# Service Bulletin

no. 78-6

**Subject:** CRANKSHAFT MAGNETO SIDE BEARING REPLACEMENT

**Models:** ALL 125 / 175 ENGINES WITH OIL INJECTION

Plastic caged bearing

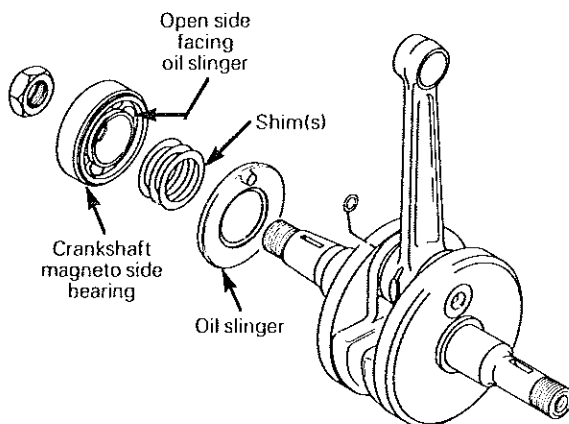
On the above mentioned engines, a new replacement magneto side bearing has been introduced. This bearing is a plastic cage type, which has shown a better durability over the regular steel caged type.

This bearing replaces the steel caged bearing type and is available under part number 420 232 761

At assembly, to ensure proper lubrication, fit plastic cage bearing with open side facing oil slinger.

ACTUAL SIZE

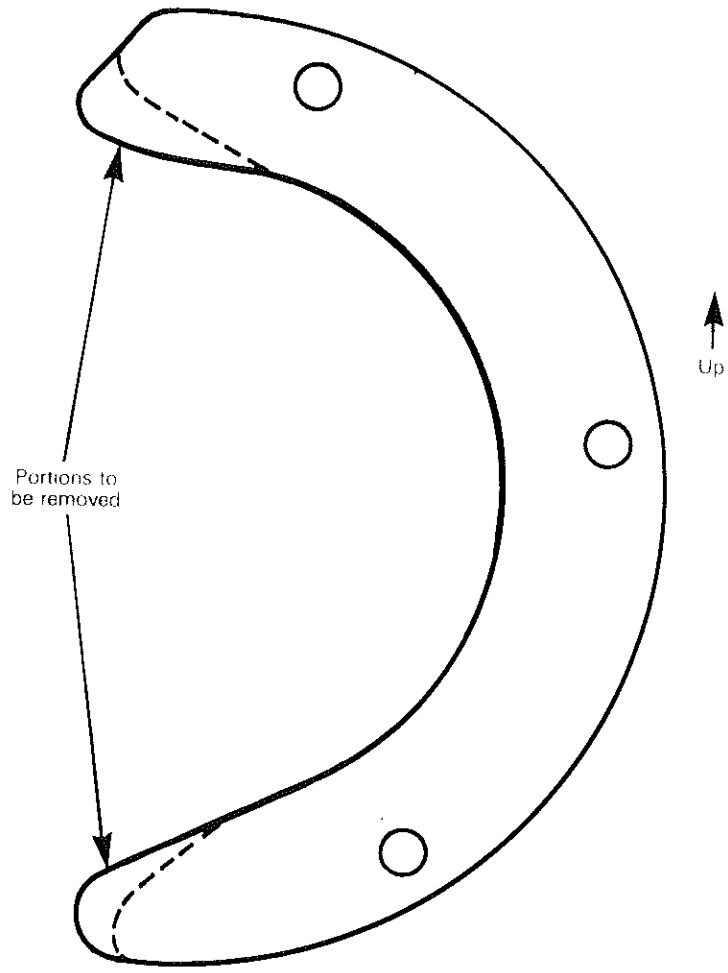
Due to the improved swing arm/chain geometry set-up, it is recommended to slightly modify the engine chain guard to prevent any possibility that drive chain comes into contact with chain guard, on severe riding conditions.

Remove engine chain guard and remove material as per template.

○ NOTE: Use a grinder and gradually remove material.

Subject: OPTIONAL AIR FILTER SOCK

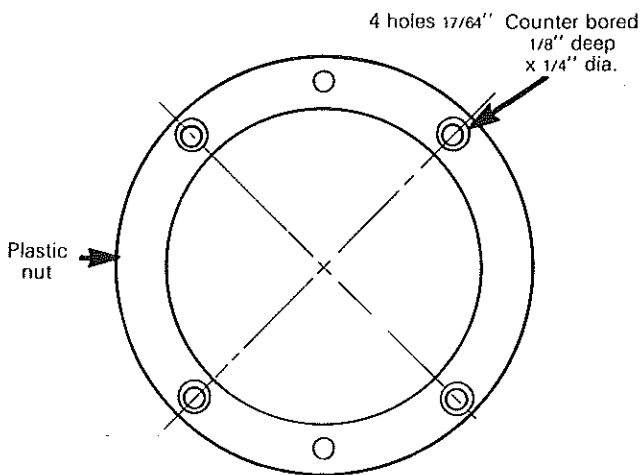
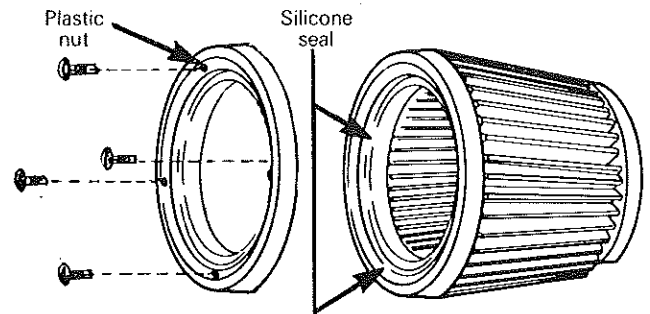
An optional oil wetted air filter sock (slip on type) is available under P/N 740 009 004.

Also it is suggested to secure the plastic nut to the bottom portion of the air filter element with 4 screws.

Drill 4 holes  $17/64''$  dia, equally spaced through the nut. (counter bore the four holes  $1/8''$  deep with a  $1/4''$  drill).

Apply a coat of silicone seal onto the air filter bottom edge to form a water tight seal.

Then, secure the plastic nut to the air filter with the four (4) retaining screws. Allow sufficient time for the silicone seal to cure. (approx. 15 min).

Sujet: SOUPAPE À CLAPET

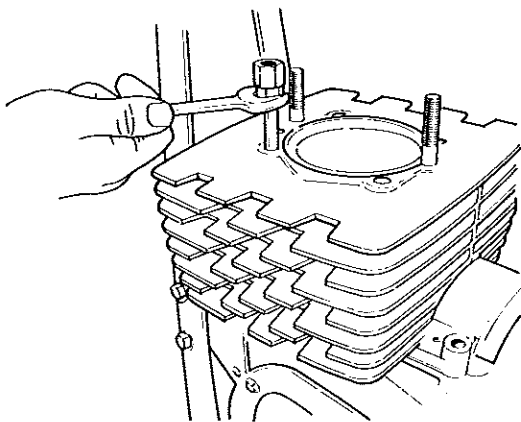
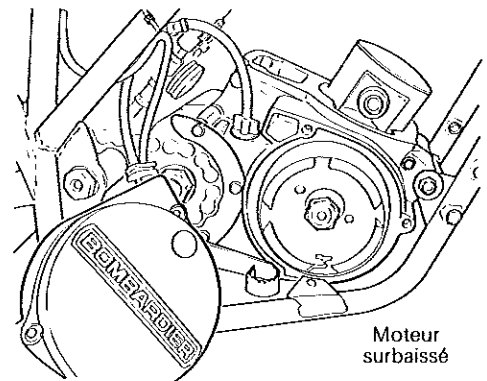
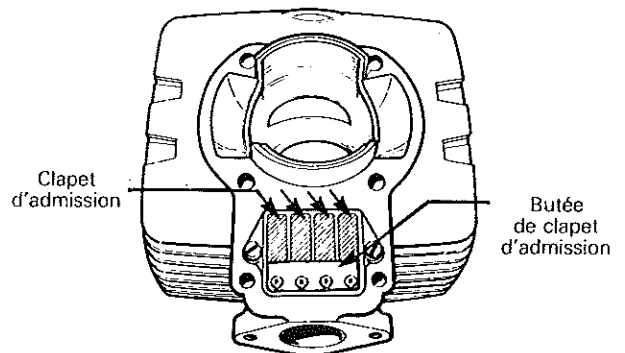
Les véhicules ci-haut mentionnés comportent maintenant une nouvelle soupape à clapet. Cette nouvelle soupape a été redessinée, de façon à offrir un fonctionnement plus sûr.

Les différentes pièces de cette soupape améliorée peuvent être obtenues sous les numéros de pièce suivants:

clapet d'admission	420 224 160
butée de clapet d'admission	420 224 170

Pour remplacer la soupape à clapet, déposer les quatre (4) vis (N/P 420 240 350) qui retiennent la butée du clapet d'admission.

Remplacer le clapet d'admission et installer la butée de clapet d'admission; s'assurer de la placer de la façon indiquée par l'illustration.

Enduire de "Loctite rouge 271" (haute résistance) les vis de retenue et remonter le tout dans l'ordre inverse de la dépose. Serrer les écrous de culasse à 26 N•m (19 lb-pi). Resserrer le boulon du bras pivotant à 102 N•m (75 lb-pi).

## SHIFTING MECHANISM ADJUSTMENT

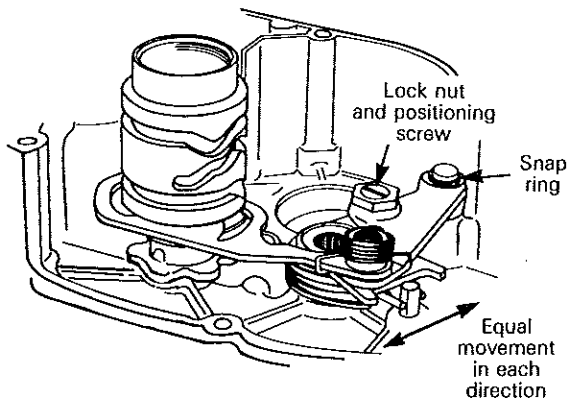
To adjust shifter drum actuating pawl proceed as follows. Position shift drum ass'y in 2nd gear or above to obtain an even travel at the actuating lever.

Then with the shift shaft in position, gently move shift lever in each direction from the middle position until shifter pawl contacts the shifter drum pin and note the amount of movement in each direction at the actuating lever.

Movement in both direction must be equal. If not, the pawl ass'y can be repositioned by unlocking the lock nut and adjusting the pawl positioning screw. Lock the nut and verify. Repeat until the travel is equal on both sides.

When final adjustment has been reached, apply Loctite no. 242 (medium strength) on the lock nut threads and torque to 27-29 N•m (20-22 ft-lbs).

Subject: SHIFT DRUM ASS'Y

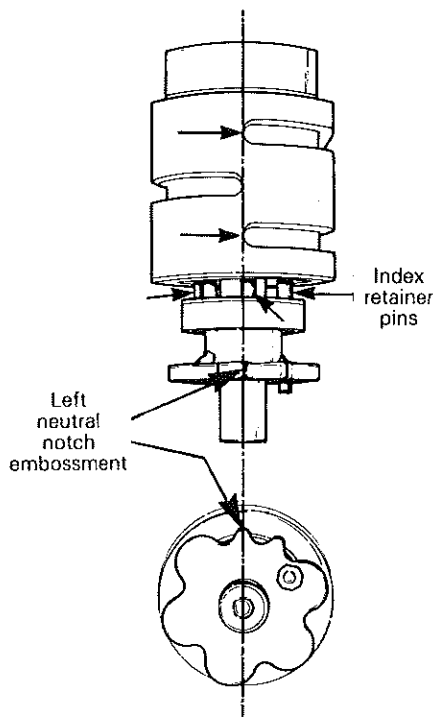
If erratic shifting or no shifting is experienced, it is recommended to check if the the shift drum index plate has not slipped on the shift drum and to adjust the shifting mechanism.

To secure the assembly, clamp the shift drum in a vise in order to press the index plate and the bushing against the shift drum then, weld the index plate to the bushing and weld the bushing to the shift drum. Tig welding (electrical) is recommended.

Position the index plate by aligning the left neutral notch embossment with the two grooved ends, on the shift drum.

Subject: ENGINE PERFORMANCE

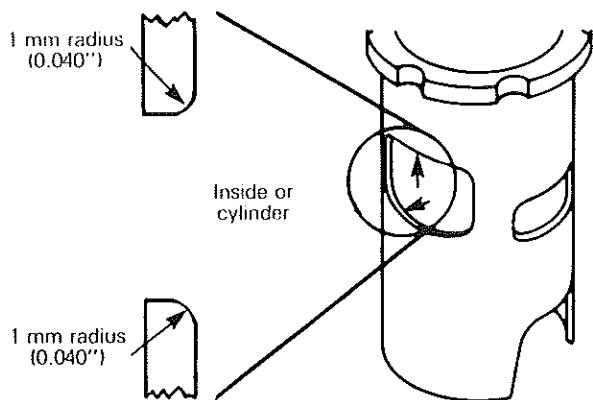
In order to further improve the performance of the MX-4 125 engine (124 engine type), the following modifications may be performed:

1. Check the upper and lower edges of the exhaust ports to ensure that a sufficient chamfer is present.

The chamfer should be of approximately 1 mm (0.040") radius. To correct, use a rotary grinder and a rubber bonded wheel.

▼ CAUTION: When grinding, ensure that the Nickasyl coating is not peeled or chipped.

▼ CAUTION: Excessive chamfer will alter port timing.

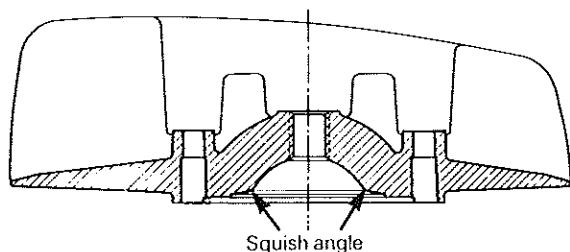
2. Install a 2-ring piston, P/N 420 993 435.

Remove the cylinder head and machine the squish angle to 16°.

Remove the old piston and install the new piston with rings.

L-trapez ring (top)	420 215 105
rectangular ring (bottom)	420 215 175

– Piston/cylinder wall clearance:	.050-.085 mm (.002"-.003")
– Ring end gap:	0.2-0.35 mm (.008"-.014")

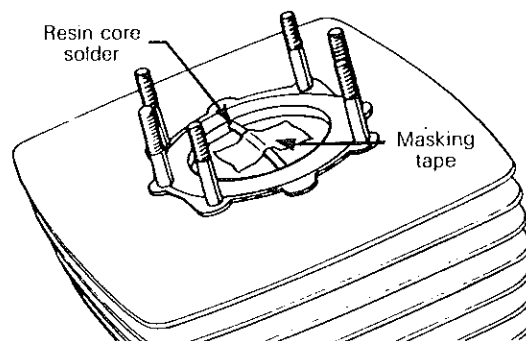
At installation, adjust the squish area to 1.52 mm (.060") by removing or adding cylinder head shims.

Bring the piston to 1/4" B.T.D.C. and place a length of resin core solder (maximum of 1/8" diameter) across the piston, making sure it is positioned parallel to the wrist pin to obtain an equal reading on each side of the cylinder.
